AP1000 DESIGN CERTIFICATION REVIEW

Draft Safety Evaluation Report Open Item Response

DSER Open Item Number: 3.7.2.3-2 (Revision 1)

DSER Open Item Number: 3.7.2.9-1 (Revision 1)

Figure 3.7.2.9-1-1: Node 532 – FRS comparison - Y Direction

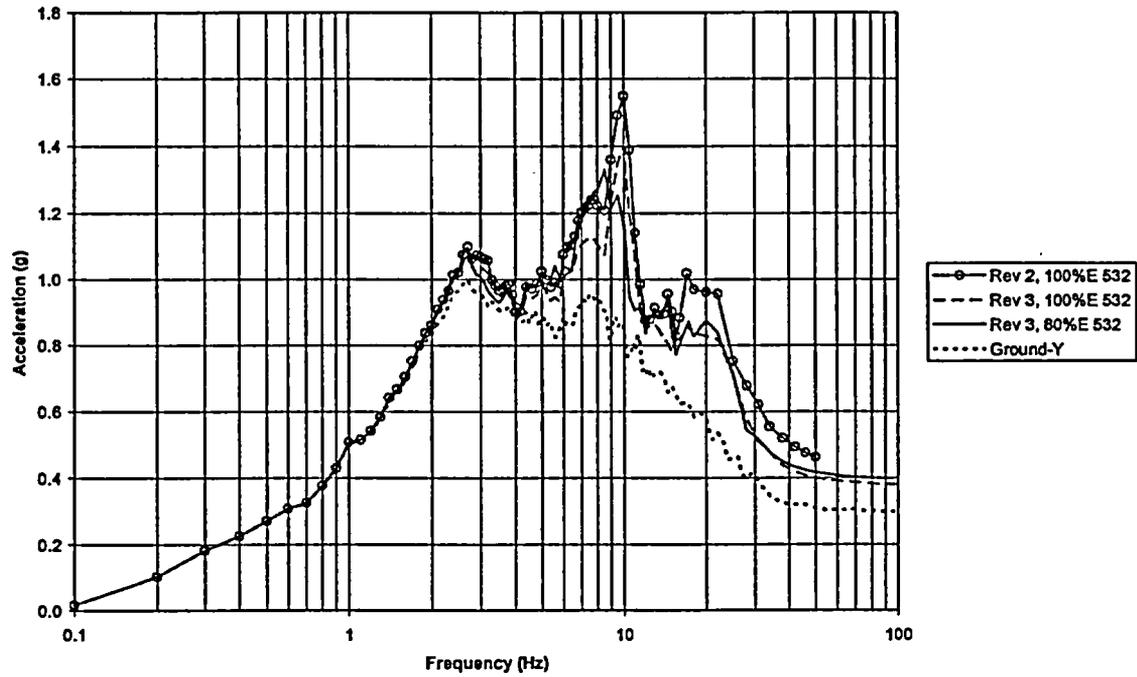
As described in DCD Tier 2 Section 3.7.2.9, as part of accounting for parameter uncertainty, Westinghouse in its response to DSER Open Item 3.7.2.3-1 shows floor response spectra which include the effects of stiffness reduction due to shear wall concrete cracking. In comparing the floor response spectra published in DCD Revision 3 which was based on uncracked concrete properties (100% E), and DCD Revision 6 which is based on partially cracked concrete properties (80% E), it is found that in most instances the 80% E analysis, shows increases in floor response spectra peaks. There are a few instances however where the floor spectra peaks have been reduced. Examples of this are the floor response spectra in the EW (Y) direction of the containment internal structures nodes 532 and 535. The staff would like Westinghouse to cite the reasons that can explain the change in the reduction at these two locations.

Figures 3.7.2.9-1-1 and 3.7.2.9-1-2 show the floor response spectra in the EW (Y) direction of the containment internal structures nodes 532 and 535. The differences between the Rev 2 100% E spectra and the Rev 3 100 %E spectra are due to a more accurate representation of the nuclear island model (including the SCV being attached to the CIS). This more accurate representation included smaller masses at these locations as well as new beam properties based on the CIS finite element model stiffness analyses. The differences between the Rev 3 100% E spectra and the Rev 3 80 %E spectra are due to change from uncracked to partially cracked concrete properties. The reduced stiffness changes cause slight changes in the nuclear island mode shapes that reduce the response in this location.
